STATE OF TENNESSEE
DEPARTMENT OF TRANSPORTATION
DESIGN DIVISION
NASHVILLE, TENNESSEE 37243-0348

INSTRUCTIONAL BULLETIN NO. 11-21

Regarding Revised Standard Drawings

Effective for the March 23, 2012 letting, the revised Standard Drawings are to be printed with the plans. These drawings shall be identified on the lower left side of the index sheet **"To be printed with plans"** until the drawings are formally distributed.

TRAFFIC CONTROL FOR ONE LANE CLOSURE ON MULTI-LANE DIVIDED HIGHWAY (WITH EARLY MERGE)

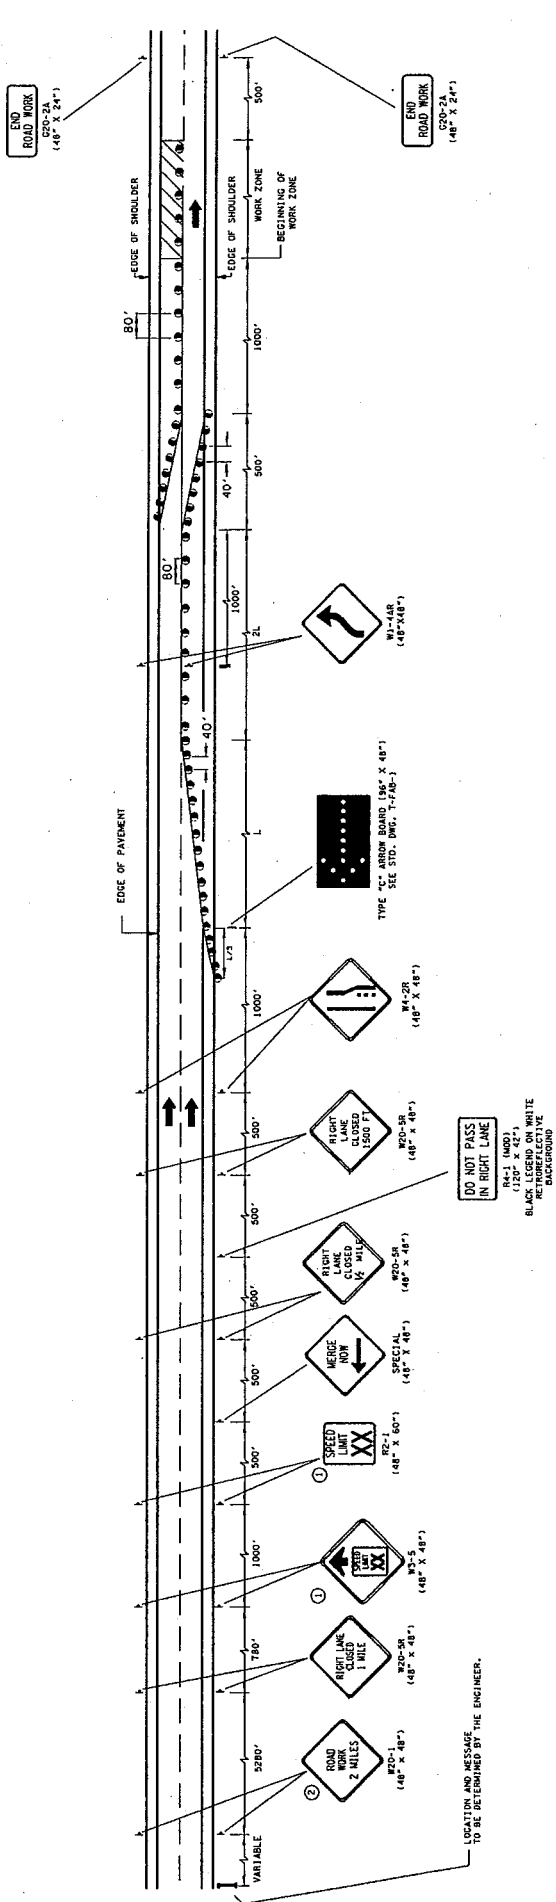
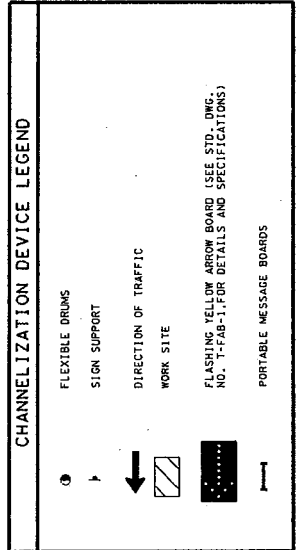
- REV. 9-1-05, REMOVED TYPE 'C' WARNING LIGHTS FROM FLEXIBLE DRUMS IN TAPER.
- REV. 3-15-11, CHANGED SIGN (R2-5A) TO SIGN (R3-5) AND CHANGED DIMENSIONS TO BE COMPATIBLE WITH SIGN (R3-5) AND COMPUTATION FOR DISTANCE. REMOVED SIGN R4-1 (400').

HANDICAP RAMP AND TRUNCATED DOME SURFACE DETAIL

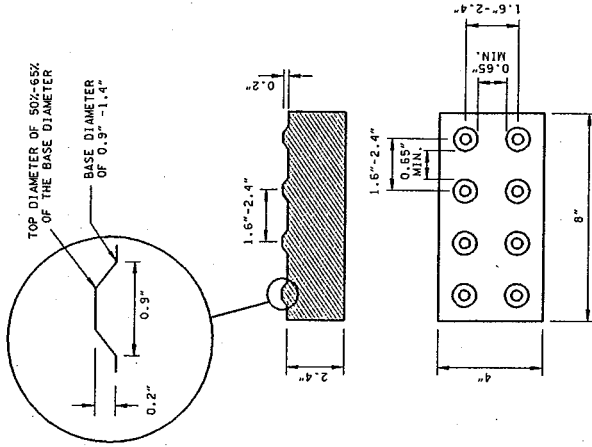
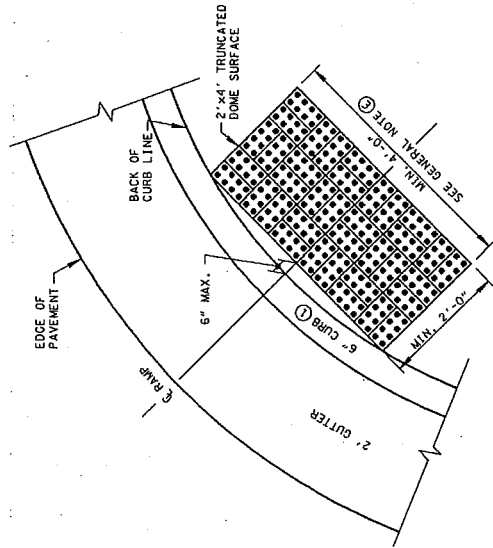
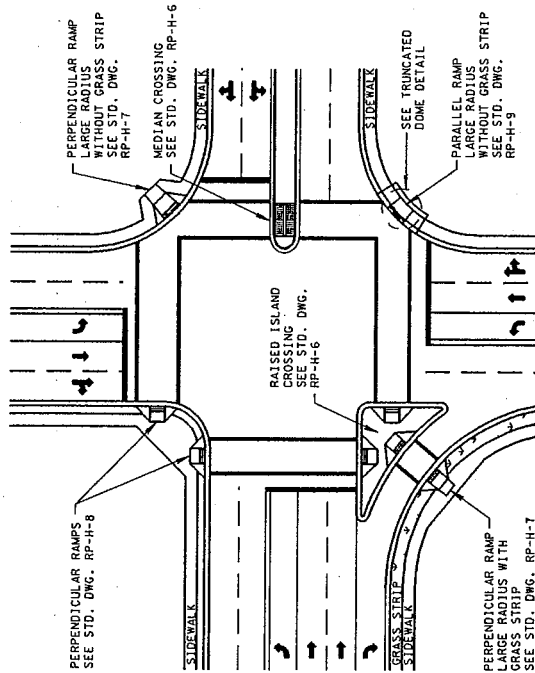
- REV. 7-17-01, REVISED SIZE AND QUANTITY OF MATERIALS. ADDED NOTE (C) MODIFIED SPECIAL PAVEMENT NOTES.
- REV. 04-13-11, ADDED LOWERED CURB FOOTNOTE (D) TO THE TRUNCATED DOME SURFACE DETAIL. MISC. EDITS TO DRAWING.

NOTE (D) CURB SHALL BE LOWERED ACROSS ENTIRE WIDTH OF RAMP

PERPENDICULAR CURB RAMP

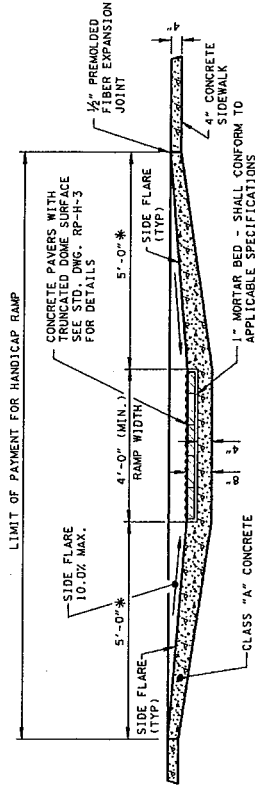
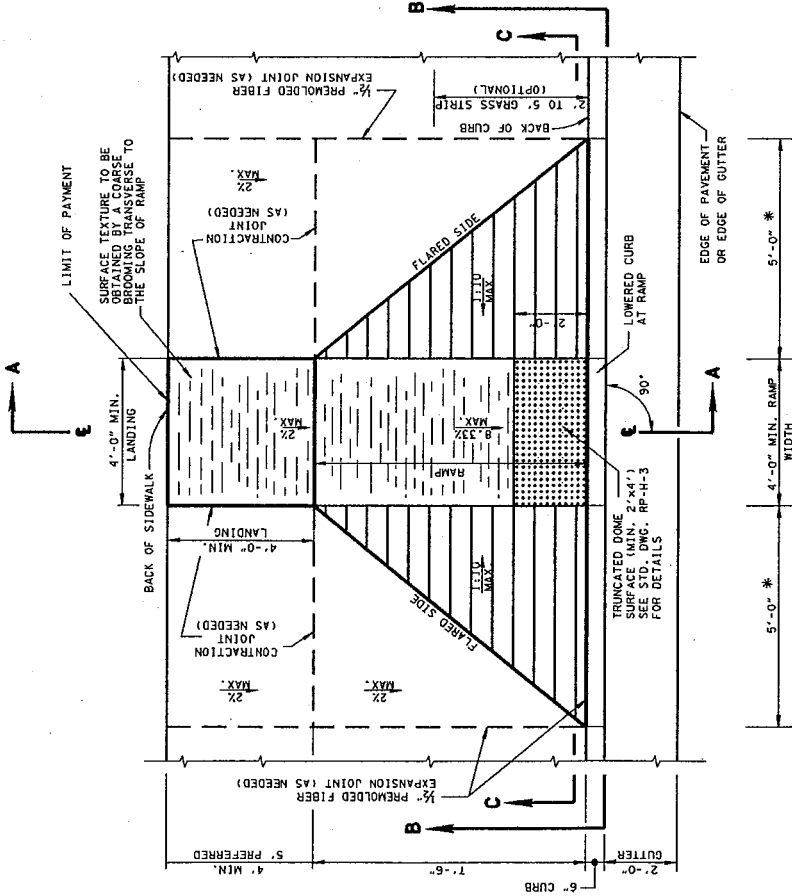
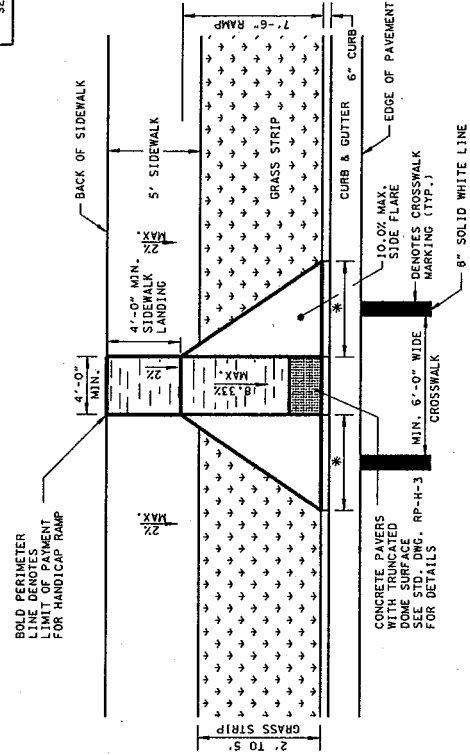
REV. 4-13-11: ADDED CURB NOTE AND REVISED RAMP DIMENSION IN SECTION A-A. ADDED FOOTNOTE D. MISC. EDITS TO DRAWING.

PARALLEL CURB RAMP DETAIL

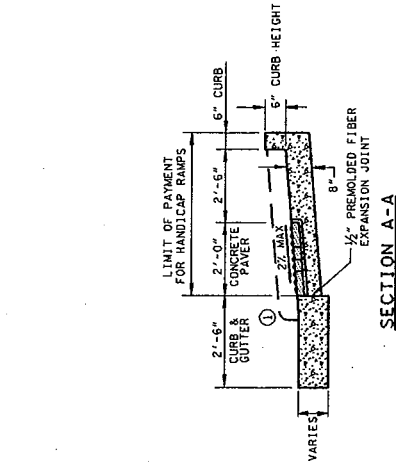
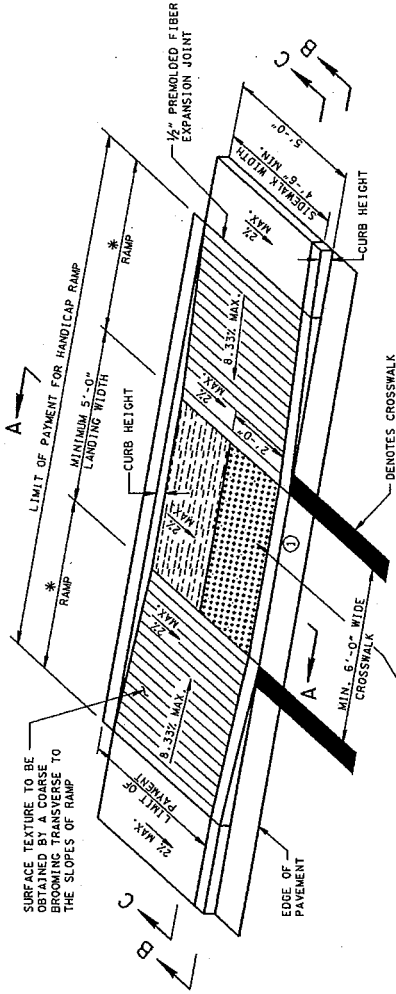
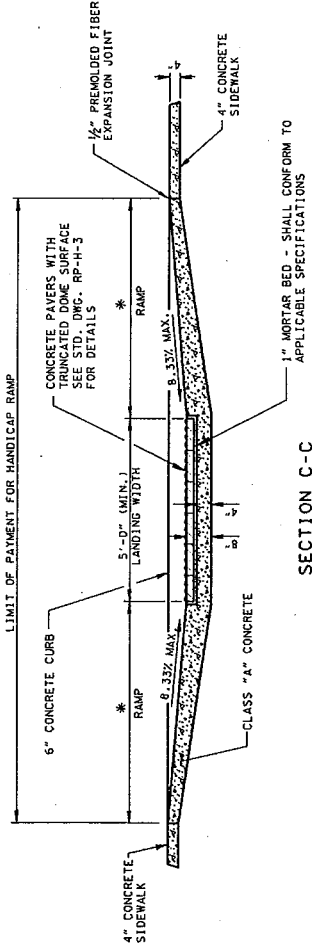
REV. 4-13-11, ADDED FOOTNOTE ①, ADJUSTED DIMENSIONS IN RAMP DETAIL, MISC. EDITS TO DRAWING.

NOTE ① CURB SHALL BE LOWERED ACROSS ENTIRE WIDTH OF RAMP.

MEDIAN CROSSING

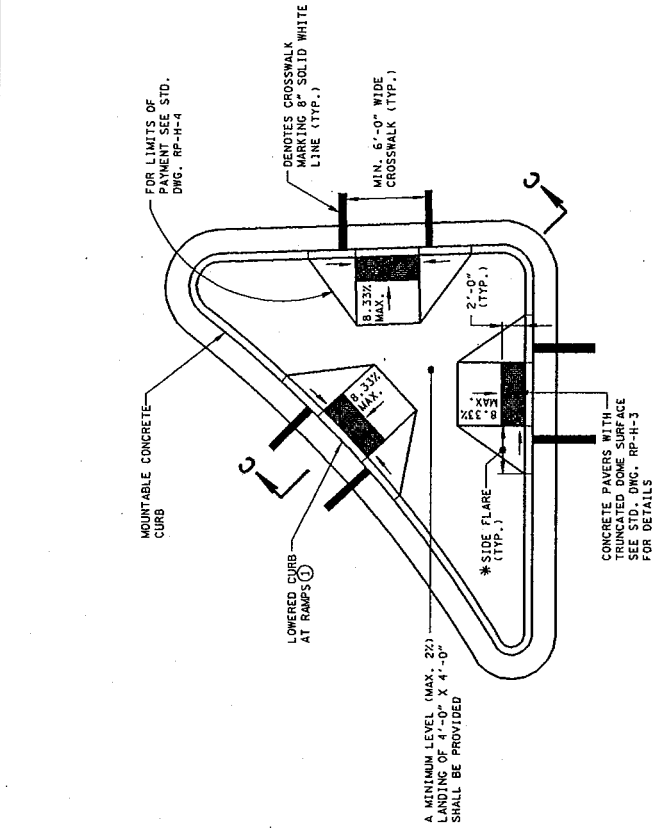
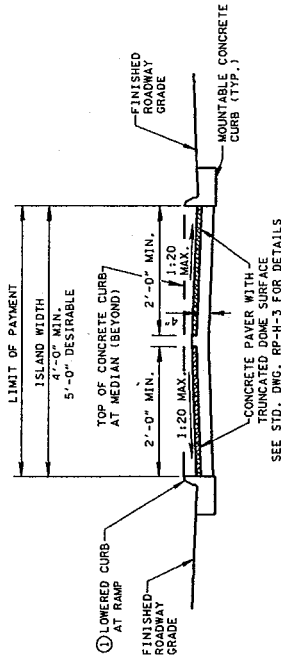
REV. 4-13-11: CHANGED CURB TYPE, ADJUSTED CROSSWALK MARKINGS, ADDED FOOTNOTE (D), MISC. EDITS TO DRAWING.

NOTE (D) CURB SHALL BE LOWERED ACROSS ENTIRE WIDTH OF RAMP.

STATE OF TENNESSEE
 DEPARTMENT OF TRANSPORTATION
 PERPENDICULAR
 HANDICAP RAMP
 FOR 20' THRU 75'
 RADIUS
 1-15-07 RP-H-7

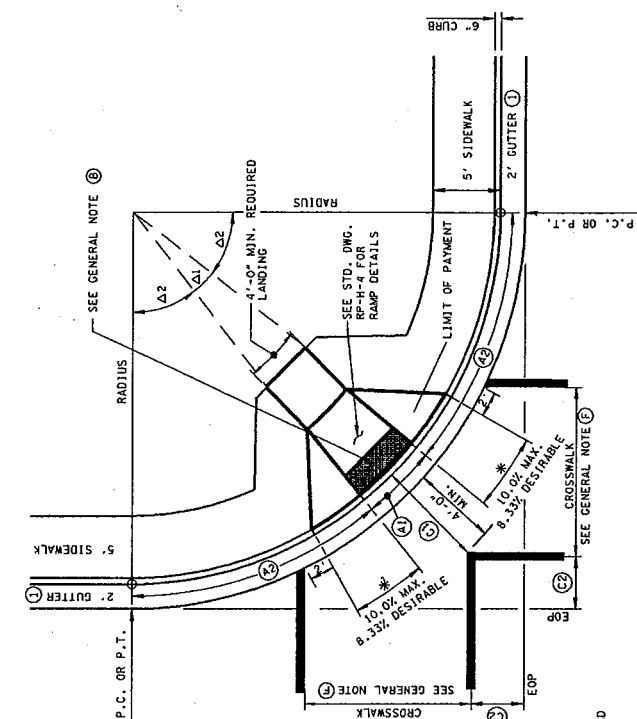
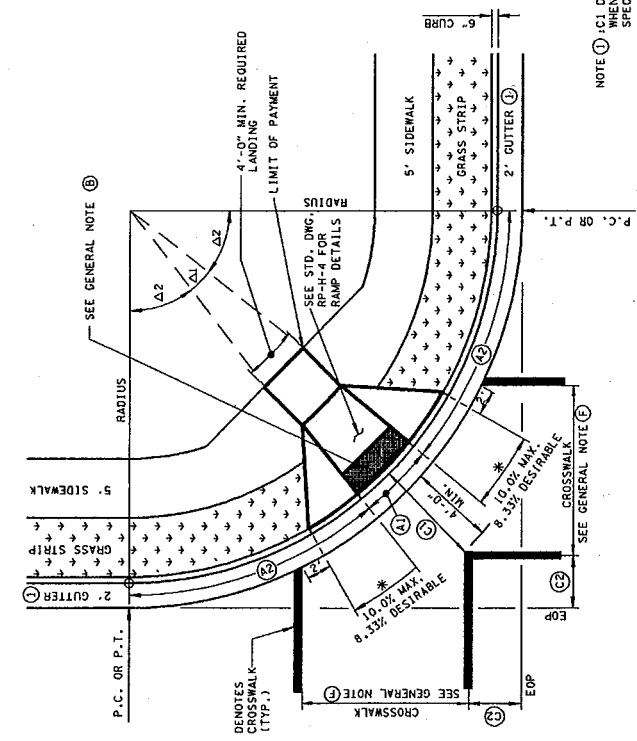
REV. 4-12-11, REVISED TABLE
 TO REFLECT THE ADDITION OF
 A 10' SIDEWALK, A 2' GUTTER,
 AND
 A 6" CURB TO THE CROSSWALK
 INTERSECTION DIMENSION.

PERPENDICULAR
HANDICAP RAMP
FOR 20' THRU 75'
RADIUS

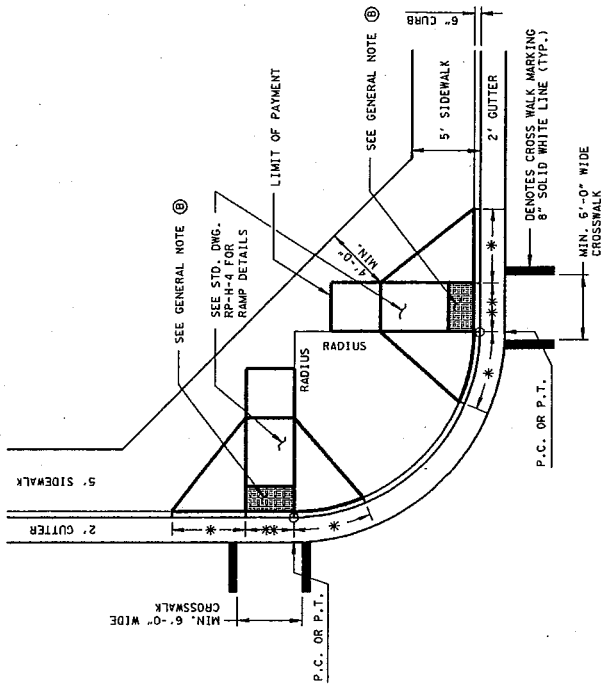
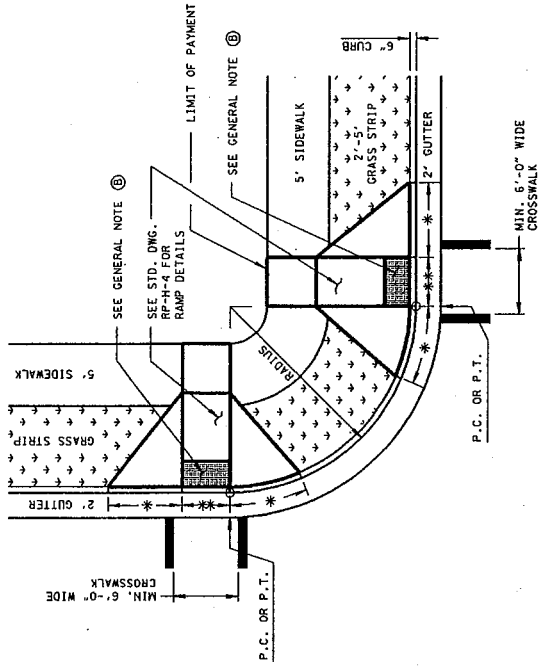
REV. 6-13-11, ADJUSTED CROSSWALK MARKINGS TO MEET ADA REQUIREMENTS. SEE DIMENSION, MISC. EDITS TO DRAWING.

PARALLEL HANDICAP RAMP FOR 20' THRU 75' RADIUS

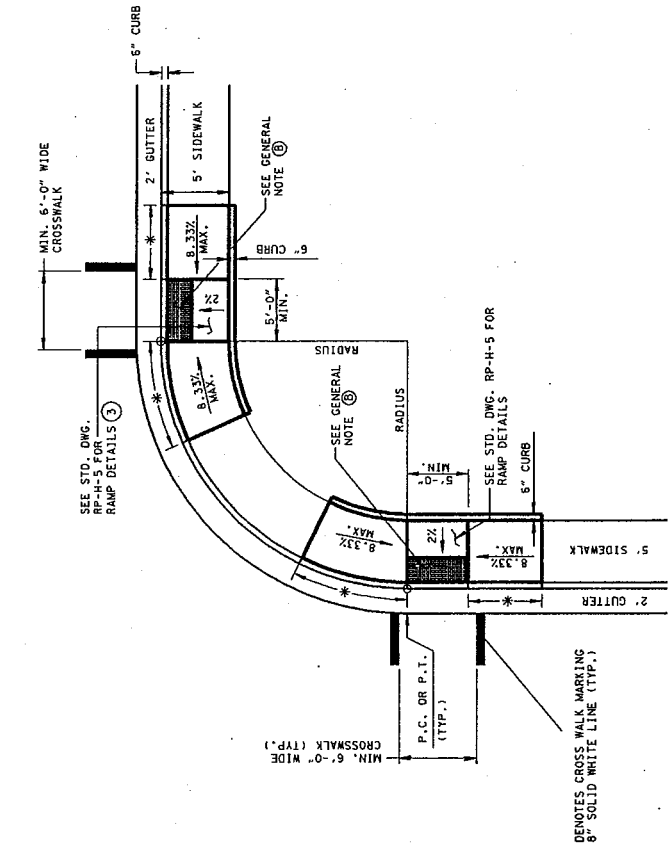
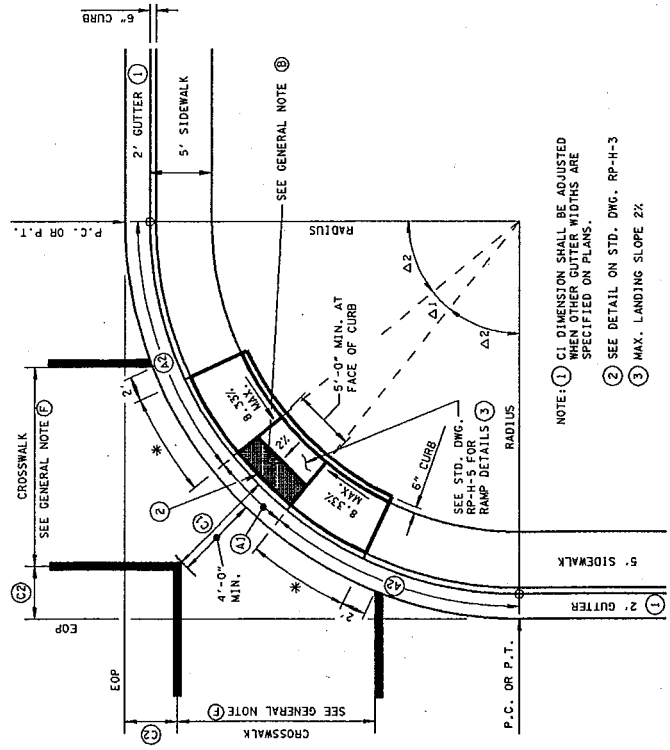
REV. 4-12-11: ADJUSTED CROSSWALK MARKINGS. ADDED NOTE (C) REVISED DIMENSIONS FOR CROSSWALK INTERSECT DIMENSION. OTHER MISC. EDITS TO DRAWINGS.

STANDARD LIGHTING DETAILS CONDUIT, CABLE INSTALLATION T-L-4

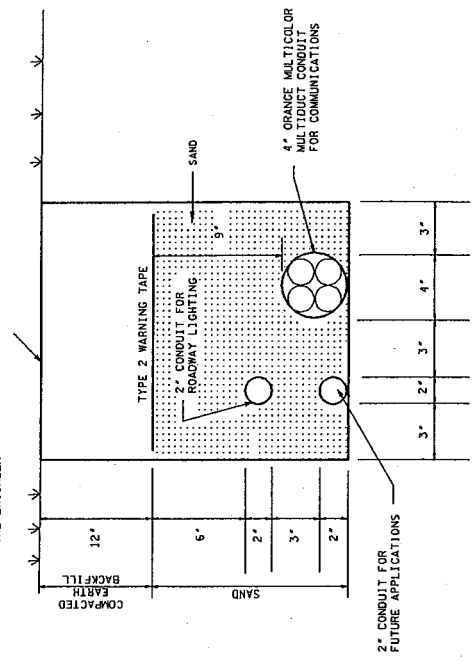
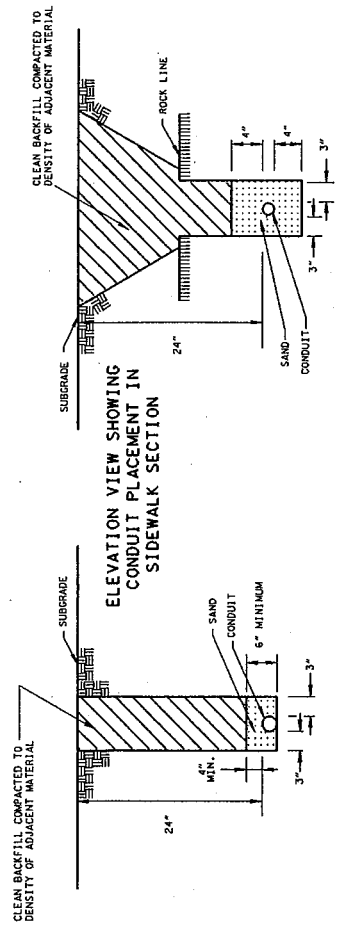
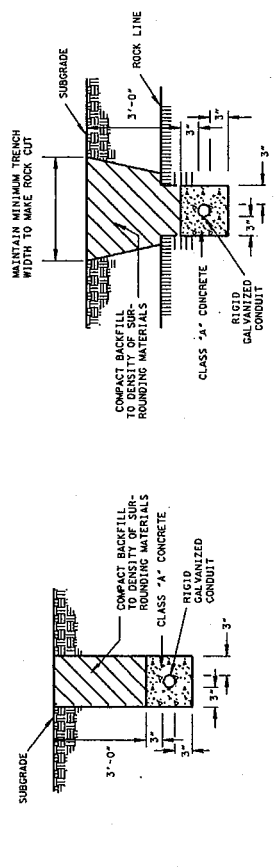
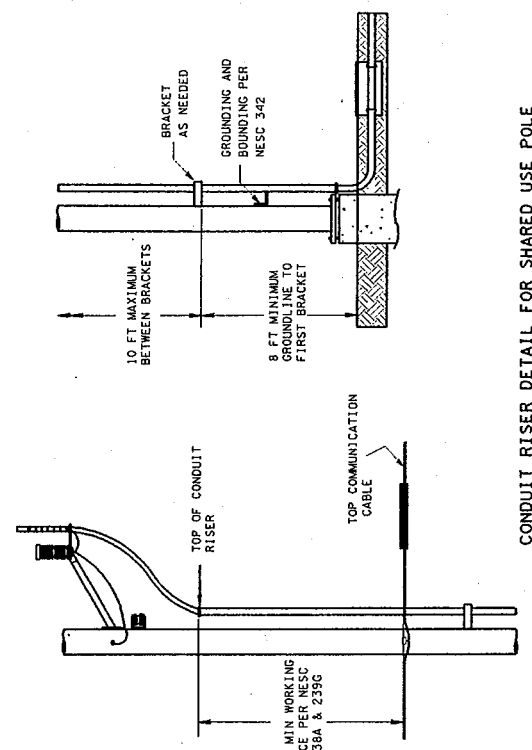
- REV. 5-25-11: ADDED CONDUIT REAR PLUGS FOR ALL COMM/POWER SHARED USE UTILITY POLES.
- REV. 2-28-06: REWORK SHEET ON CADD AND MADE MINOR CHANGES.
- REV. 12-16-03: DELETED SPLICING DETAIL, AND ADDED COMM/POWER BACKBONE TRENCH LAYOUT.
- REV. 7-29-04: ADDED TRENCH LAYOUT FOR COMM/POWER BACKBONE DETAIL. PLEASE DELETE ALL DETAILS AT TYPICAL SPLICING AND JOINT DETAILS.

LOCATION OF BRIDGE APPROACH GUARDRAIL DELINEATORS

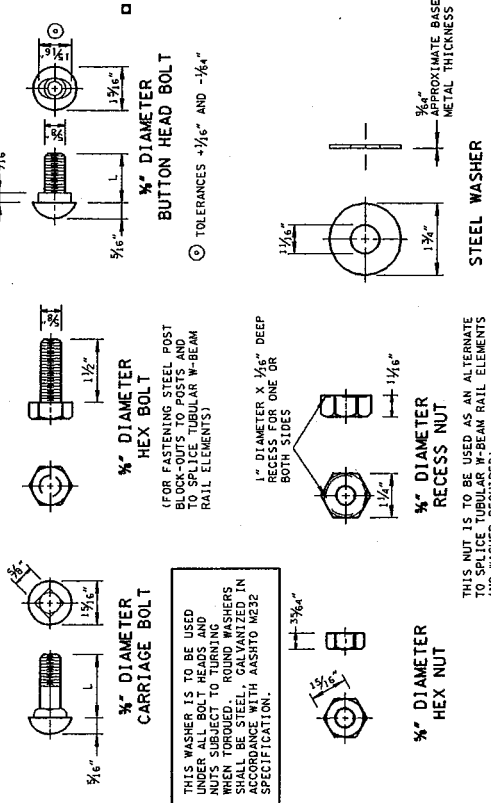
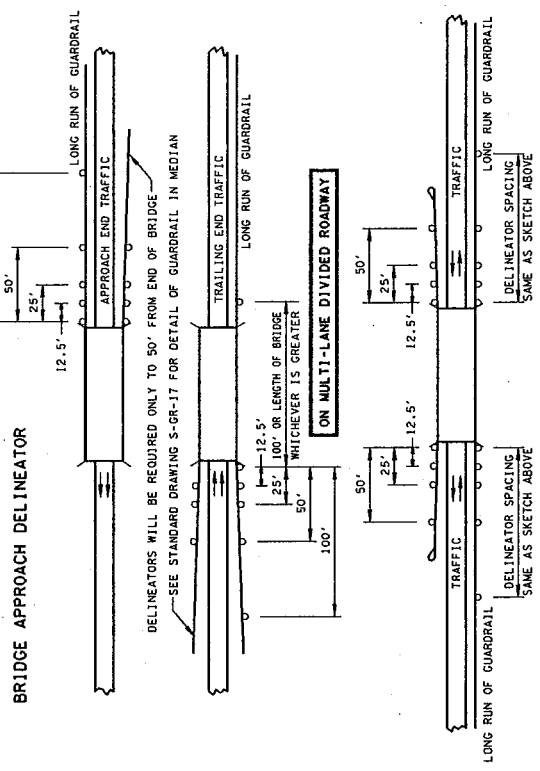
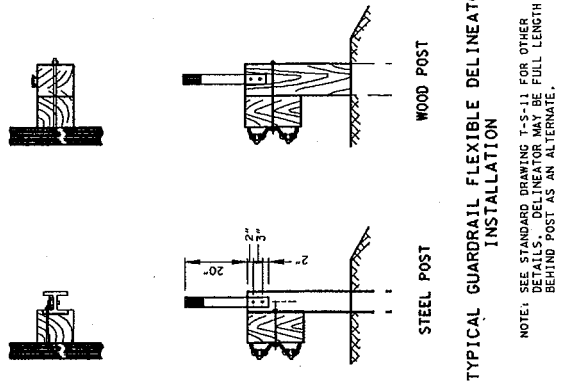
REV. 5-1-85: REDREK SHEET AND CHANGED GUARDRAIL TO FLEXIBLE DELINEATOR.
 REV. 11-14-85: CHANGED 3/4" BOLT AND NUT DETAILS.
 REV. 3-1-86: ADDED TO DELINEATOR NOTE.
 REV. 11-4-87: ADDED 3/4" RECESS NUT TO DRAWING.
 REV. 10-26-91: REDREW AND UPDATED DRAWING TO 1991 STANDARDS.
 REV. 1-19-92: MODIFIED CODING SYSTEM ON GENERAL NOTES AND SPECIFICATIONS.
 REV. 7-29-98: CHANGED FLEXIBLE DELINEATOR TO DELINEATOR.
 REV. 9-5-98: CHANGED BEAM BARRIER TO W-BEAM BARRIER. DELETED DETAIL FOR SQUARE WASHER FOR BUTTON HEAD BOLTS.
 REV. 6-6-11: REORGANIZED NOTE.
